Response to Request for Information – DA-301/2026

Proposed Affordable Housing Residential
Flat Building at 15 Spence Street & 171-173
The River Road, Revesby

August 2026

Figure 1: Principal COS (Lodgement), Thomson Adsett, 16/02

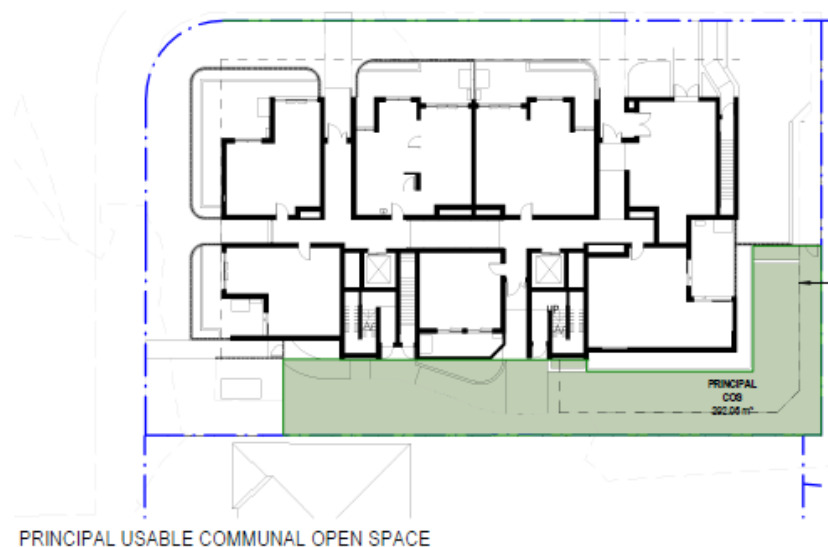
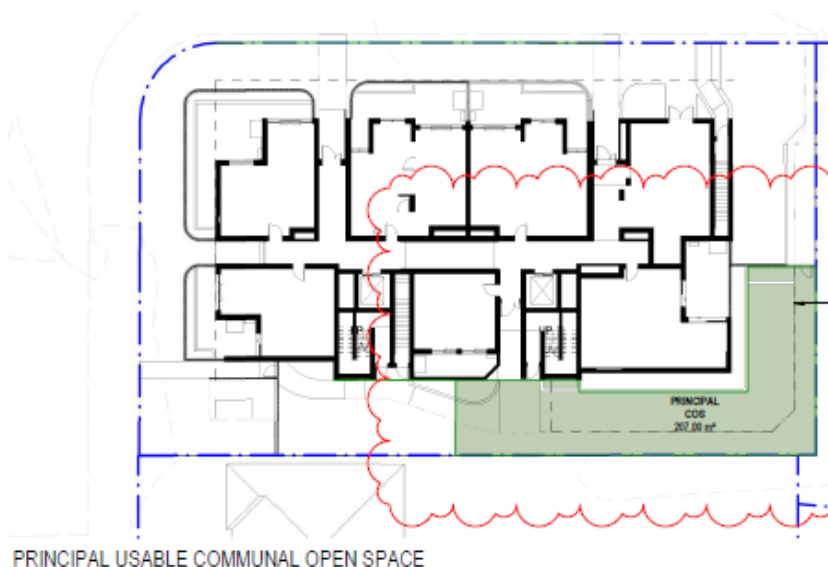
Apartment Design Guide	
The submitted drawings indicate that only 103.50m² of the Principal Usable Communal Open Space (292.06m²) receives a minimum of	The principal communal open space has been amended as part of this response, as noted on drawing No. A-4-45. The principal communal open space now receives 50% of solar access for at least 2 hours on the 21 June in accordance with

2 hours direct sunlight between 9am and 3pm on 21 June. This represents 35.4% of the Principal Usable COS, which does not satisfy the ADG requirement of 50% minimum (146m² required). Revised plans must be submitted demonstrating full compliance with the solar access provisions of the ADG.

the guidelines of the Apartment Design Guide. See Figures 1 and 2 below.

The SEE acknowledges that the principal communal open space does not achieve the ADG target of 50% receiving two hours sunlight. However, the proposal has been amended in response to Council's RFI letter dated 2 July 2026, such that the principal communal open space now receives 50% solar access in accordance with the guidelines of the ADG 3D-1.
